MEMORANDUM FOR FILES

SUBJECT: Ambler Asbestos Piles Superfund Site, OU1 & OU2, Ambler, PA – Site Inspection Report

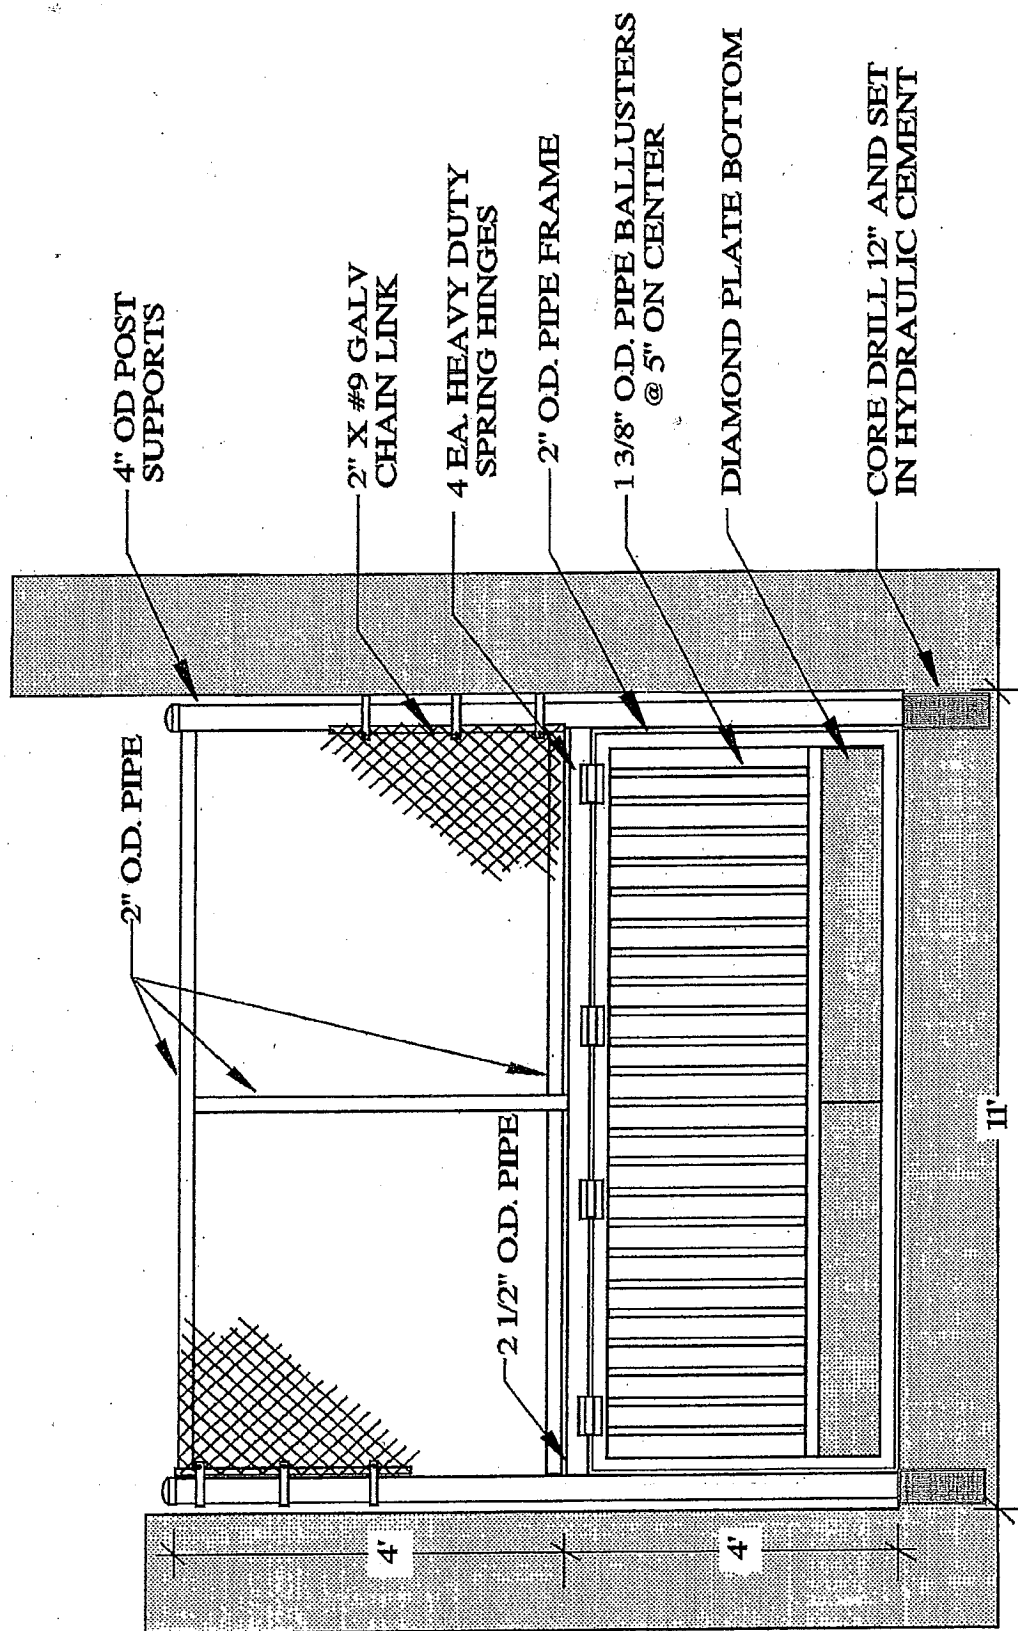
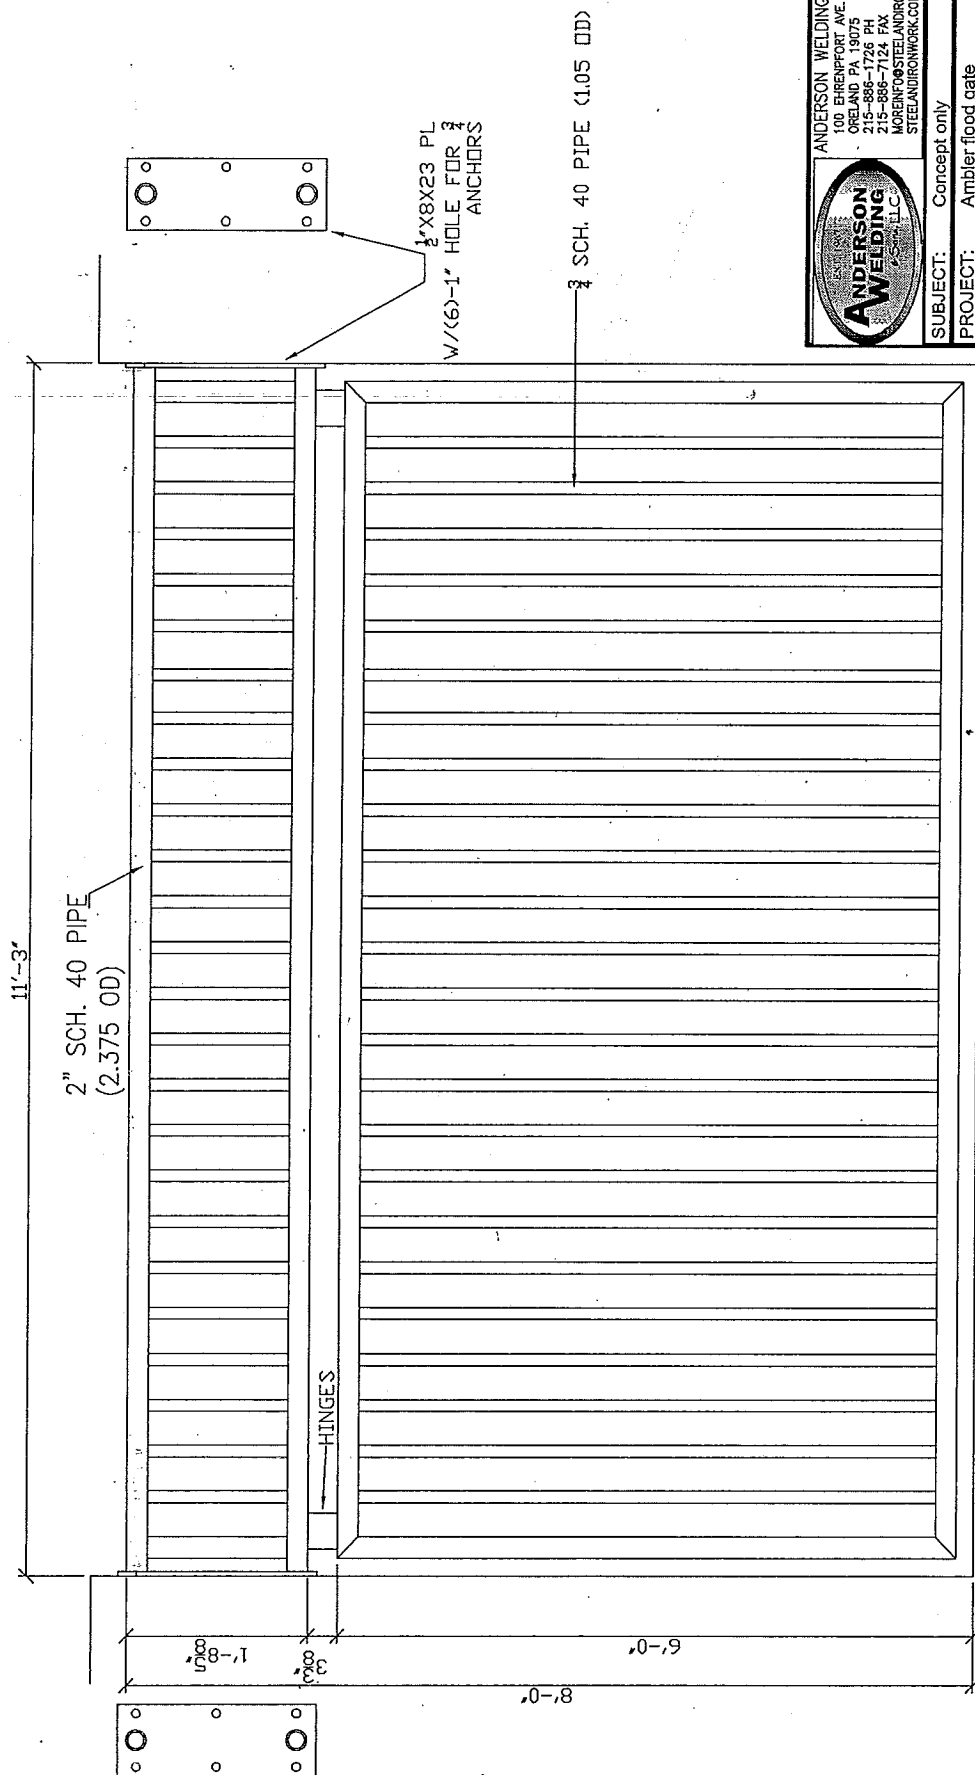
Vegetation that was observed on the Upper Locust Street Pile (see attached map) during the September inspection had been recently mowed. According to Mr. Williams, the vegetation rebounds after mowing and he will begin spraying it with an herbicide in spring.

The inspection team also saw downed trees at 40.14960, -75.22673 and 40.14903, -75.22511. There were animal burrows at 40.14924, -75.22617; 40.14914, -75.22491; and 40.14909, -75.22480. The soil cover should be repaired in these areas as soon as possible. See the attached map for reference.

7.7 Holes in the soil cover should be repaired at: 40.14960, -75.22673; 40.14903,-75.22511; 40.14924, -75.22617; 40.14914, -75.22491; and 40.14909, -75.22480.

FLOOD RELEASE GATE

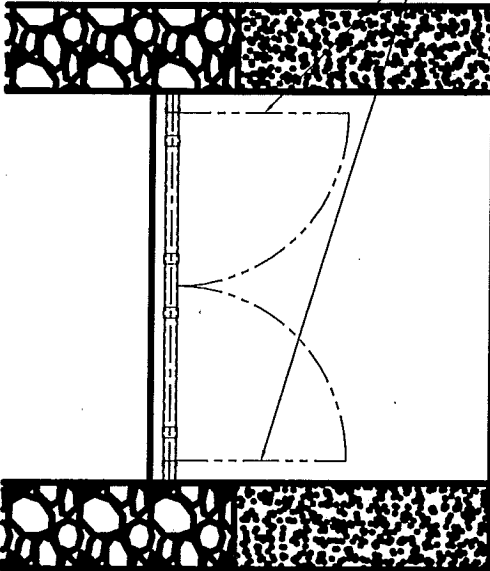
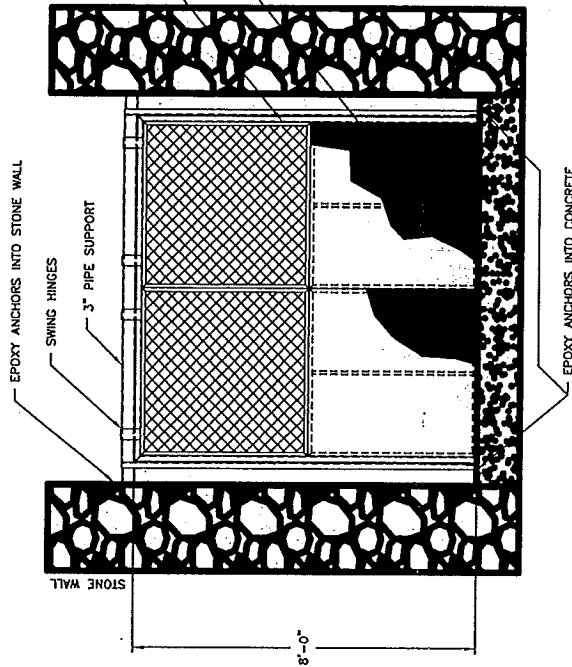
The fence near the “brick drain” outlet located along the southwest side of the Upper Locust Street Pile is still clogged with debris from flooding. The EPA, USACE, WSP, and Bartlett discussed alternatives to the current fence running across the culvert. It was decided that WSP will have the clogged fence removed and add to the existing perimeter fence to maintain restricted access. A swing gate similar to one installed for the BoRit project along Maple Street will be installed across the culvert. This will limit children from entering the culvert but will allow water and debris to flow freely. WSP has proposed to line the channel with geotextile and rip rap. Some minor regrading/filling may be necessary to reestablish the channel subgrade prior to installing the geotextile and riprap. See attached drawings for three designs from the Borit gate.

7.3 The clogged fence at the drainage outlet should be removed and a swing gate should be installed on the stone culvert. The site should be secured by adding fence or making it higher as required. The erosion at the outlet should be repaired using geotextile/rip rap and possibly some fill to reestablish the eroded subgrade. (Figure 6)
